SUBJECT: Interim deficiency rept re unsupported anchors between concrete floors & equipment base plates, initially reported 801107. Caused by unfilled annular space between pipe shim & anchor. Use of Shims around anchors will be discontinued.

SUSQUEHANNA STEAM ELECTRIC STATION  
INTERIM REPORT OF A DEFICIENCY  
RELATING TO SHIMMING OF BASE PLATES  
ERs 100450/100508      FILES 840-4/900-10  
PLA-586

FIGURE 1

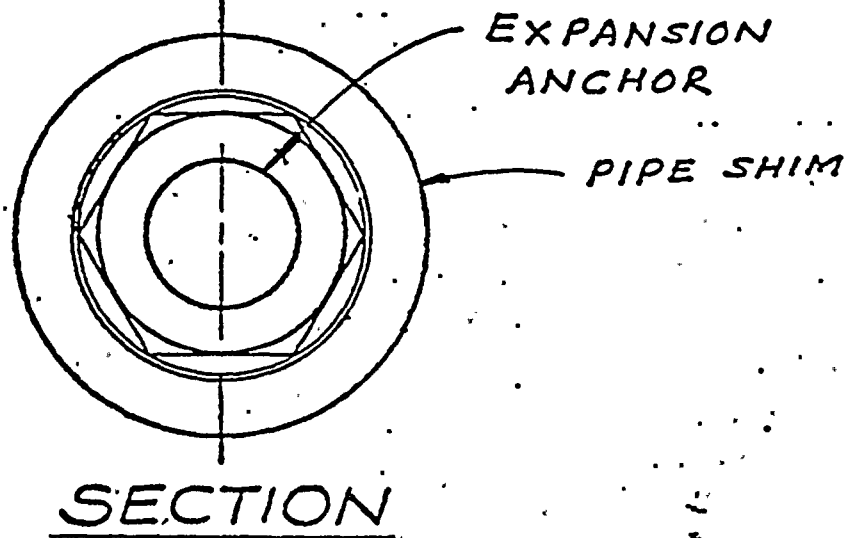
Bechtel Engineering became aware that pipe shims have been used around anchors between concrete floors and base plates. These were used for setting and leveling of the base plates of various types of supports. The majority of the existing base plates have been already grouted, however, the annular space between pipe shim and the anchor is not filled (See Figure '1'). The grout thickness (and also the height of the pipe shim) generally ranges between one and two inches. As the anchors are unsupported within the height of pipe shims, their shear capacities may be significantly reduced.

Bechtel field personnel are currently developing a field procedure for undertaking the inspection program necessary to resolve the use of pipe shims around anchors. The inspection is scheduled to commence in December 1980. Additionally, the field has established the feasibility of filling the void shown in Figure 1 with grouting material.

FIGURE 2

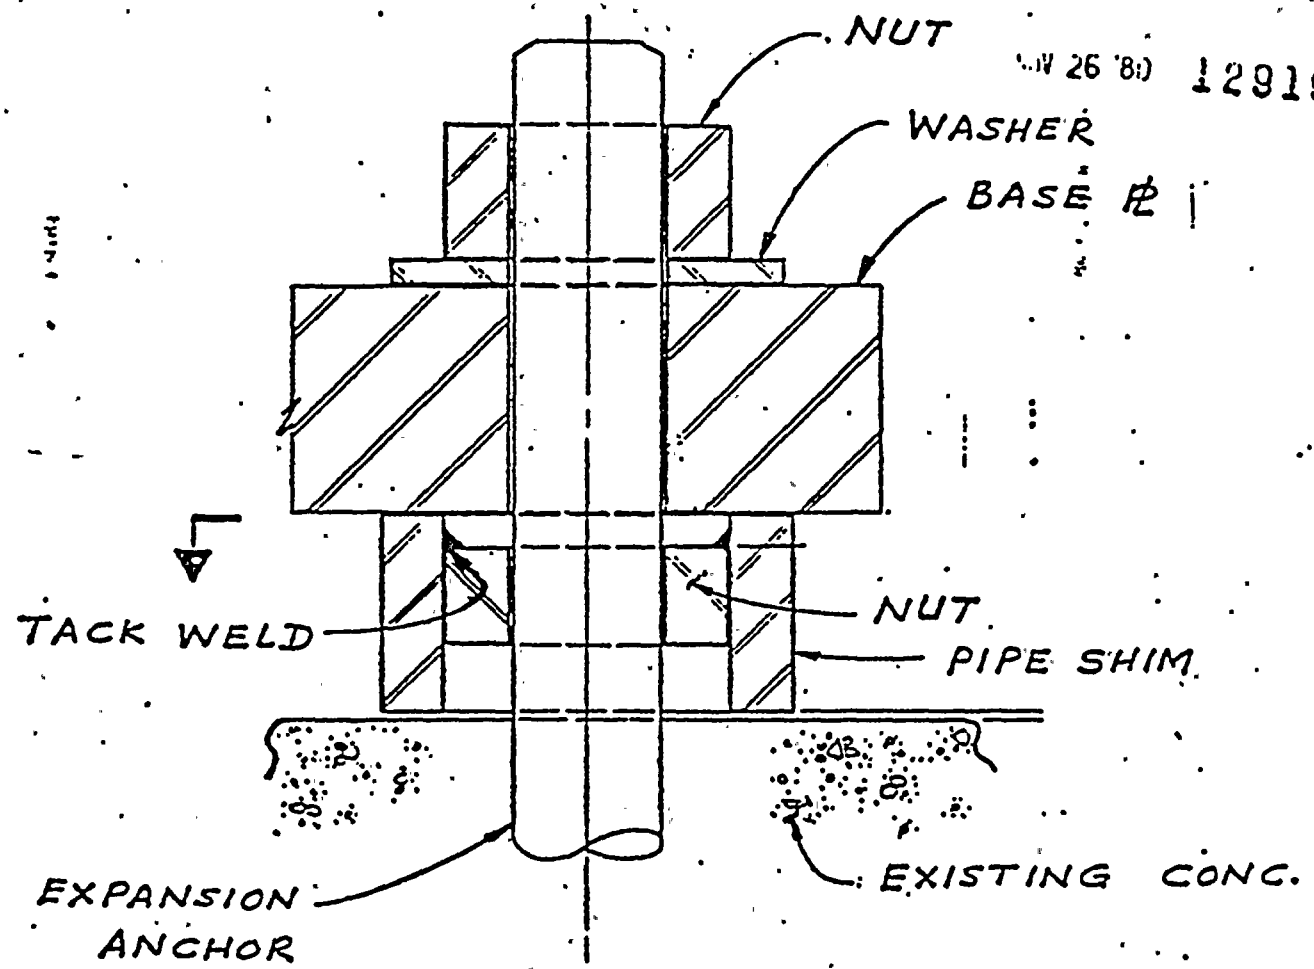
In addition to the above condition, on a few floor mounted pipe supports, it was observed that a nut was placed within the pipe shim and tack welded. (See Figure '2') This condition may have an adverse impact in developing and verifying required installation torque/prestress in the anchors.

An inspection and remedial program is presently being planned which will deal with the tack welding of leveling nuts inside pipe shims (Figure 2).
